THORNEYCROFT SUBDIVISION

APPLICATION NUMBER 14 DATE December 17, 2009

APPLICANT Thornecroft Subdivision

REQUEST Subdivision

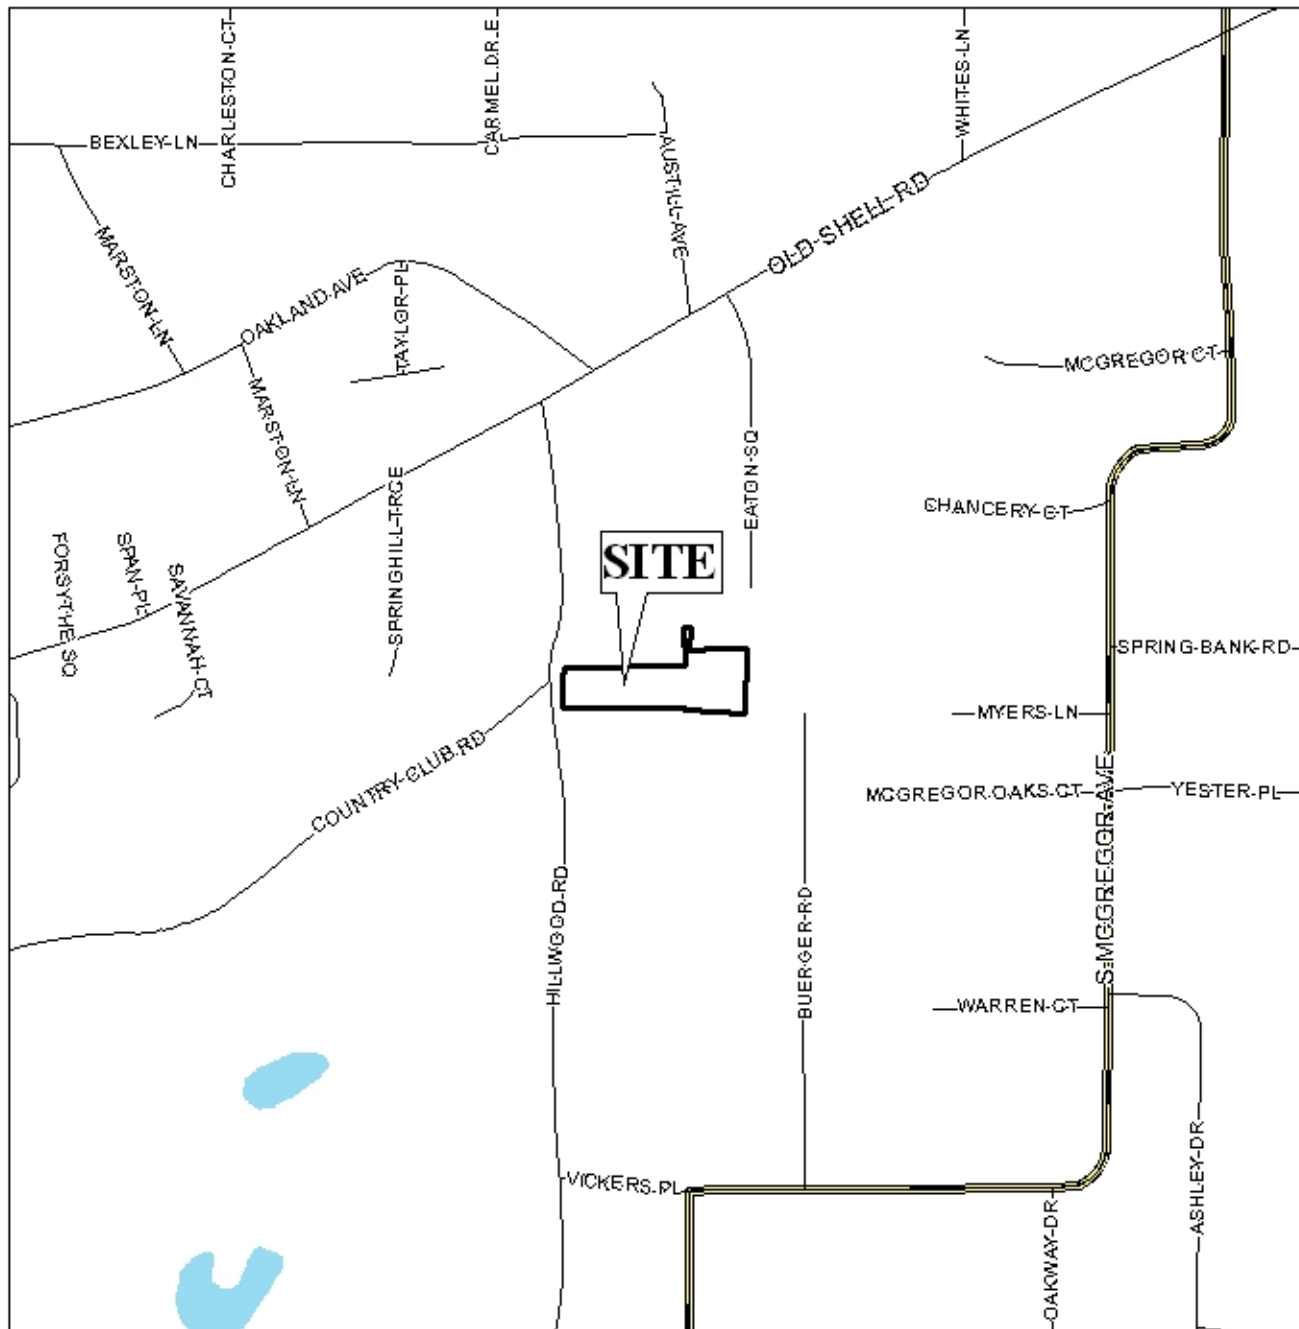
The site has approximately 100' of frontage along Hillwood Road. As a means of access management, a note should be placed on the final plat stating that the lot is limited to one curb cut to Hillwood Road, with the size, location, and design to be approved by Traffic Engineering and in conformance with AASHTO standards.

It should be noted that the proposed lot exceeds the maximum depth allowed by Section V.D.3 of the Subdivision Regulations. However, Parcel B, as it exists today, is completely landlocked and

un-developable. Therefore, combining it with the existing lot (Lot 14 Hillwood) seems to be the only feasible option for the applicant; thus, a waiver would be appropriate.

The plat meets the minimum size requirement for developments with access to public water and sewer. However, it is requested that the applicant revise the preliminary plat to label the lot with its size in square feet, or provide a table on the plat with the same information. The applicant should also revise the plat to illustrate the minimum building setback line from Hillwood Road.

- 1) placement of a note on the final plat stating that the lot is limited to one curb cut to Hillwood Road, with the size, location, and design to be approved by Traffic Engineering and in conformance with AASHTO standards;

- 2) labeling of each lot with its size in square feet, or the provision of a table on the final plat with the same information;
- 3) the depiction on the final plat of the 25' minimum building setback line along Hillwood Road;
